# Alachua County Environmental Protection Department

## MEMORANDUM

**TO:** Alachua County BoCC  
**VIA:** Stephen Hofstetter, Director  
**FROM:** Mark Brown, CPSS, Sr. PWS, Natural Resource Program Manager  
**SUBJECT:** City of Gainesville – Gainesville Community Redevelopment Agency  
Cornerstone Eastside Development  
Summary - Countywide Wetland Protection Code  
Avoidance, Minimization and Mitigation Plan

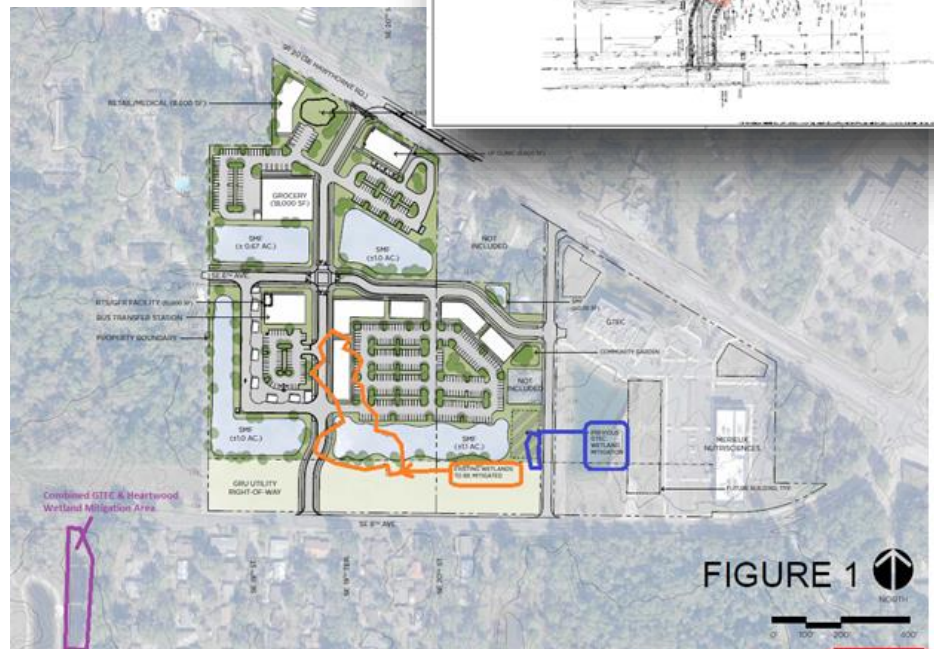
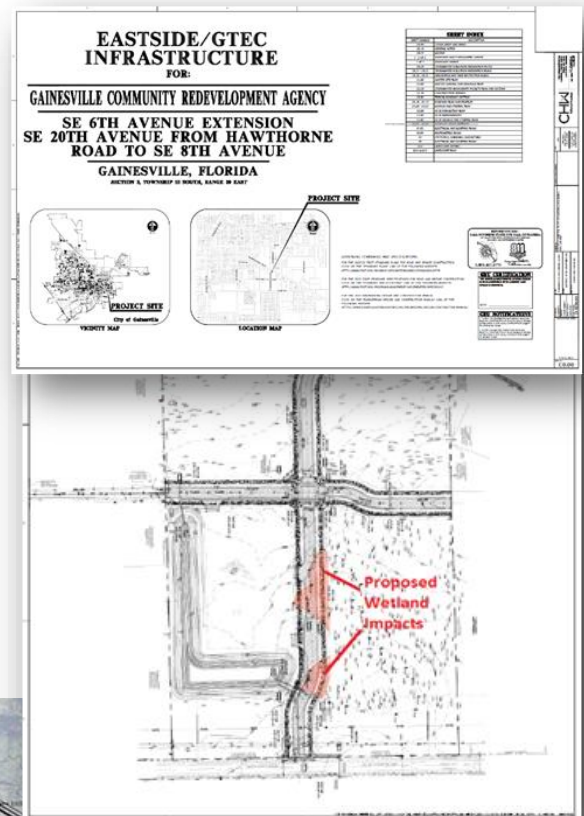
In December of last year, staff reviewed the two design plan sets submitted to the SJRWMD that included the proposed UF Health Clinic and separate plans for the “*Eastside / GTEC Infrastructure*” (two above figures). Those plans depicted proposed roadway fill of the 0.2-acre portion of the wetland delineated on the UF Health parcel. Staff provided questions to CHW requesting documentation on the avoidance & minimization evaluation conducted for this proposed roadway crossing and adjacent 75 ft. wetland buffer encroachment.

GCRA CORNERSTONE EASTSIDE DEVELOPMENT | CONCEPT PLAN 1-11-2023

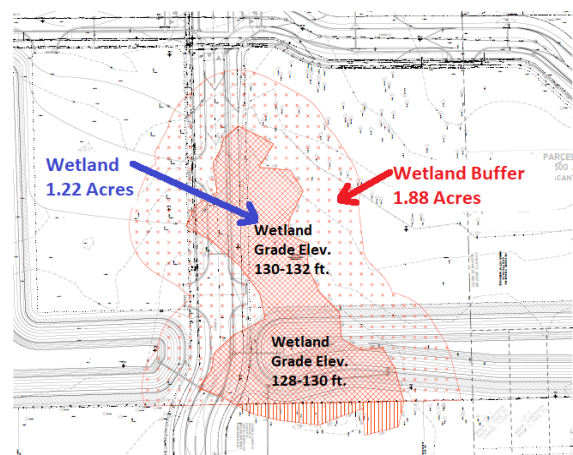
In January, CHW provided the current concept plan (Figure 1 above and right figure) that reference the proposed removal of 1.22-acres of wetland and 1.88-acres of adjacent buffer due to excavation for a stormwater basin, and fill material to construct couple buildings, access roads, and predominantly parking areas.

## Wetland Hydrology

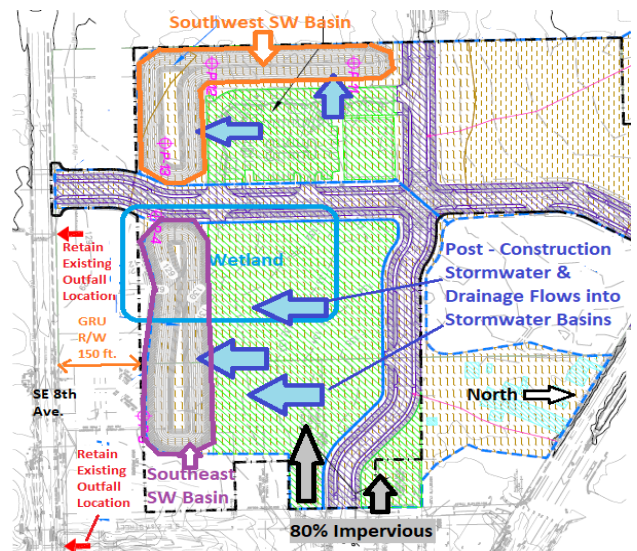
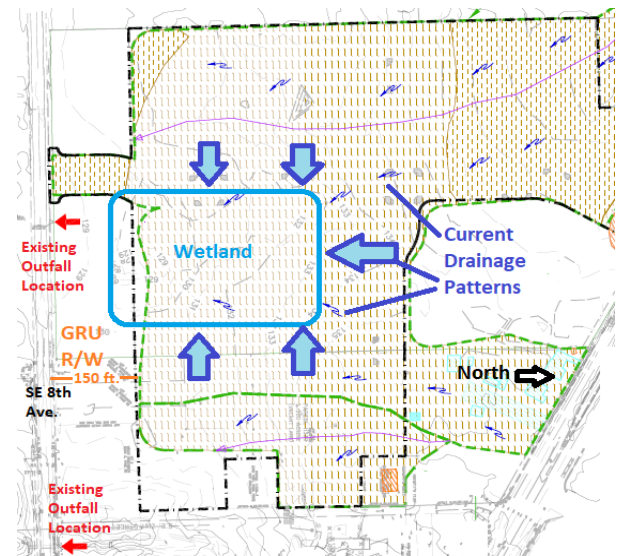
The most critical factor for the formation and maintaining appropriate wetland ecosystem functions and ecological benefits are associated with contributing hydrology factors such as surface water drainage, shallow groundwater water levels and associated rainfall. As depicted on the right figure, the existing grade elevations direct a high percentage of the contributing watershed drainage toward the 1.2-acre wetland. Evaluation of the various collected data, contours, vegetative species, hydric soil characteristics and hydrologic indicators associated with the wetland indicate the system primarily functions as a seepage system with the surficial groundwater level primarily within 2-3 feet below surface grade, with intermittent and short duration of less than six inches of surface water (hydroperiod) occurring within the lower elevations of the South Lobe (128-129 ft.). CHW provided verification that even though only 33% of South Lobe portion of the wetland is located within the GRU R/W, that area retains 75% of the available storage capacity of the South Lobe due to lower grade elevations within 30 ft. south of the R/W boundary.

With the high quantity of facilities proposed for the 22-acre project area, the alternatives assessment primarily focused on evaluating potential technical design alternatives for surface and stormwater drainage features. Primarily if and where associated stormwater treatment methods and facilities could possibly be modified to at least reduce encroachment by incorporating appropriate portions of the wetland into the design; particularly associated with the higher quality South Lobe. With a proposed post-construction design plan that includes 80% impervious within the southern half of the project site (green highlight on right figure), there will be substantial volumes of stormwater that will be directed toward the two southern stormwater basins. As a result, essentially all the current surface water drainage and large percentage of shallow groundwater that currently contributes to the wetland will be initially diverted to stormwater basins (above figure).

### **Alternative 1 – Shifting Southeastern Stormwater Basin to within GRU R/W**

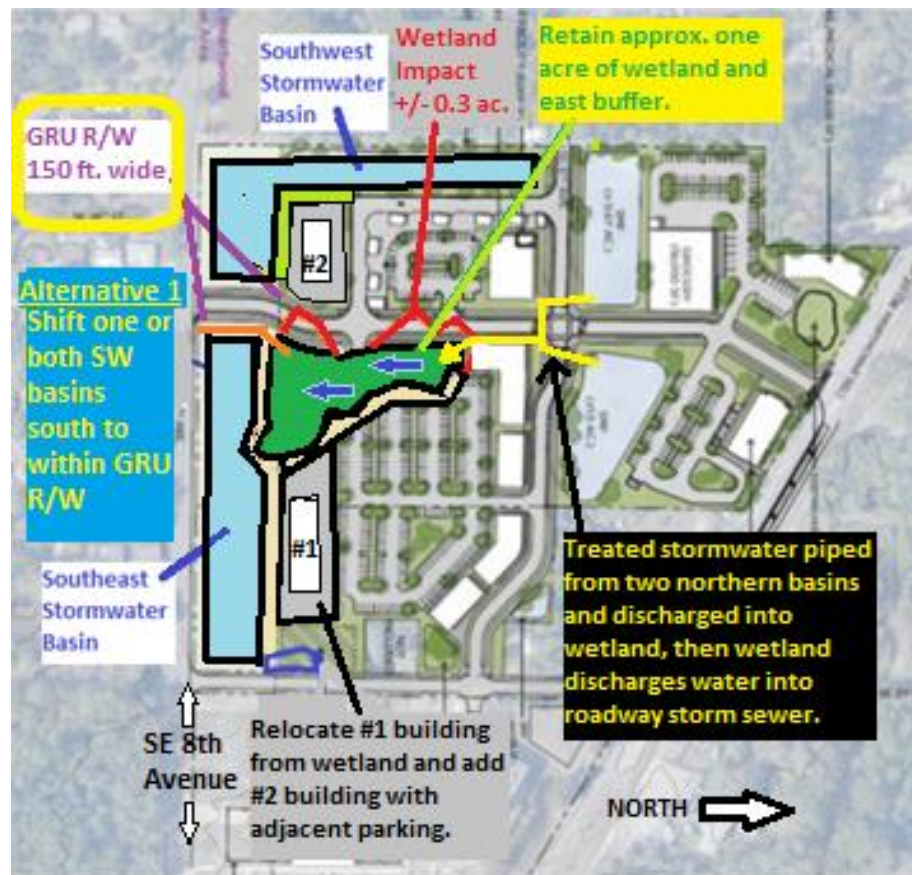
The shifting of the southeastern basin south to the adjacent cleared GRU utility R/W would make it unnecessary to excavate the southern half of the wetland. In addition, the relocation of the proposed building and some parking within the northern half of the wetland could be designated within the area currently proposed for the southeastern basin (represented by #1 building on figure). Even though shifting the southern portion of southwest basin into the R/W would not affect the wetland, it could provide an additional area for another building, parking and/or other uses (represented by #2 building on the aerial). Treated stormwater discharged from the two proposed northern stormwater basins could be routed to discharge into the northern area of the wetland where the gradual hydraulic gradient south would retain the seepage hydrology (yellow line on the figure). An overflow structure near the southwestern corner of the wetland would also ensure positive outfall and discharge of water into the roadway storm sewer system (orange line on figure). The minor roadway encroachment within the western perimeter of the wetland was not shifted west, however most of the wetland and some buffer along the eastern boundary of the wetland would be preserved and with enhanced habitat, could provide an ecological benefit and recreational walking opportunity for the Cornerstone community.

Discussions between the COG and GRU resulted in GRU agreeing to allow the proposed access road crossing over the GRU's utility R/W and connection with SE 8<sup>th</sup> Avenue. However, other potential activities that would require land clearing, earthwork and/or structures and facilities within the R/W were not supported by GRU. This requirement is also inclusive of potential modifications of existing drainage patterns. As a result, these restrictions are also factors and limitations for the other prospective alternatives. These limitations and possible options are referenced within Alternatives 2 & 3.

## Alternative 2 – Southeastern Stormwater Basin Configuration Around South Lobe Wetland

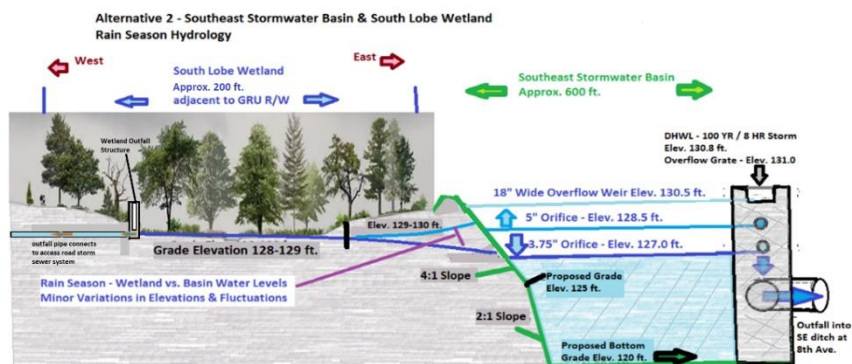
The northern half of the isolated wetland has grade elevations primarily in the range of 130-132 feet, higher than the control elevations proposed for the southeast and southwest basins. As referenced under Alternative 1, discharging treated stormwater from the two proposed northern basins and directed to flow into and through the northern portion of the wetland will be a benefit to retain seepage hydrology. The two southern and northwestern stormwater basins are designed to function as wet detention basins. Even though the northwestern basin has not been designed, it is also anticipated to be wet detention. Unlike dry basins that are typically shallow excavation and rely on soil infiltration to provide water quality treatment, wet detention

systems are generally deep excavation and rely on retaining a consistent pool of surface water to treat stormwater. As a result, the two northern stormwater basins will detain storm and surface waters for longer duration than currently drains south to the wetland. There are many variables as to whether the wet detention of the southeaster basin could provide sufficient hydrology to retain the habitat conditions within the northern portion of the wetland. It is possible a reduction in lateral groundwater seepage would eventually result in transitioning that area back to the predominantly non-wetland functions and characteristics. In turn, resulting in increasing the natural recruitment and generation of nuisance and exotic species such as the *Coral ardisia* and cogon grass currently present within the adjacent upland areas. As a result, Alternative 2 focused on potential design features that could be implemented to preserve and incorporate the lower grade elevations of the South Lobe wetland area into the surface and stormwater design.

The proposed southeast basin outfall control elevations depicted on the cross-sectional figure below, the water fluctuation range of four feet (127.0-130.0 ft.) between lowest bleed-down orifice and overflow grate are within the range to provide sufficient lateral seepage to retain appropriate ground and surface water fluctuation within the South Lobe wetland area; particularly during the typical rainy season. A separate outfall structure would be necessary within the South Lobe wetland to ensure surface waters remain within the wetland boundaries to avoid the potential of surface water sheet flowing south across the GRU R/W.

However, a secondary protection measure of surface water containment would probably still be necessary (further discussed as a critical component of Alternative 3).

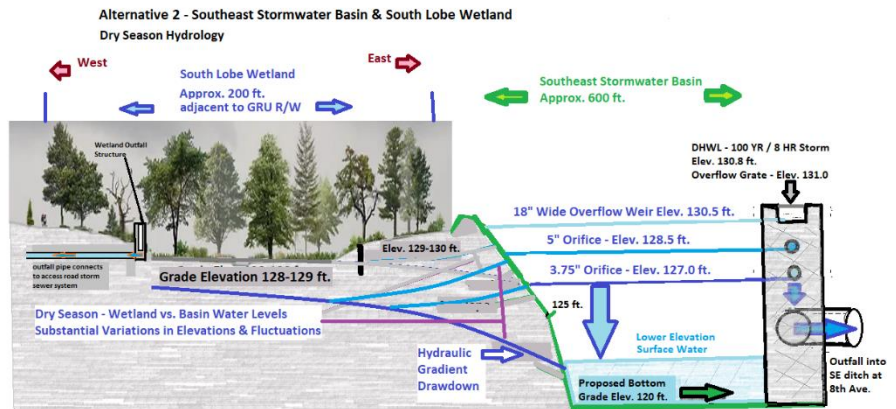
Since the two southern southwestern basins need to retain sufficient surface waters through dry seasons, the proposed bottom grade elevation of 120 ft. will be 8-10 feet lower than the surface grade elevation of the South Lobe wetland. Even during long dry seasons when surficial groundwater levels drop to the lower elevations, the soil structure matrix beneath wetlands have sufficient water holding capacity to support wetland vegetation and habitat conditions during dry seasons.

However, without the soil structure present after excavation, the hydraulic gradient drawdown of the surficial groundwater will also reduce the available moisture and saturation conditions within the South Lobe wetland (above figure). A few of the most common methods to reduce wetland gradient drawdown include:

- Increase set-back distance between the excavated basin and wetland.
- Construct gradual contours within the interior slopes of the basin closest to the wetland.
- Excavate and construct a clay core in the subsoil to reduce lateral seepage, however the core can also reduce the reverse groundwater seepage into the wetland during the rainy season.
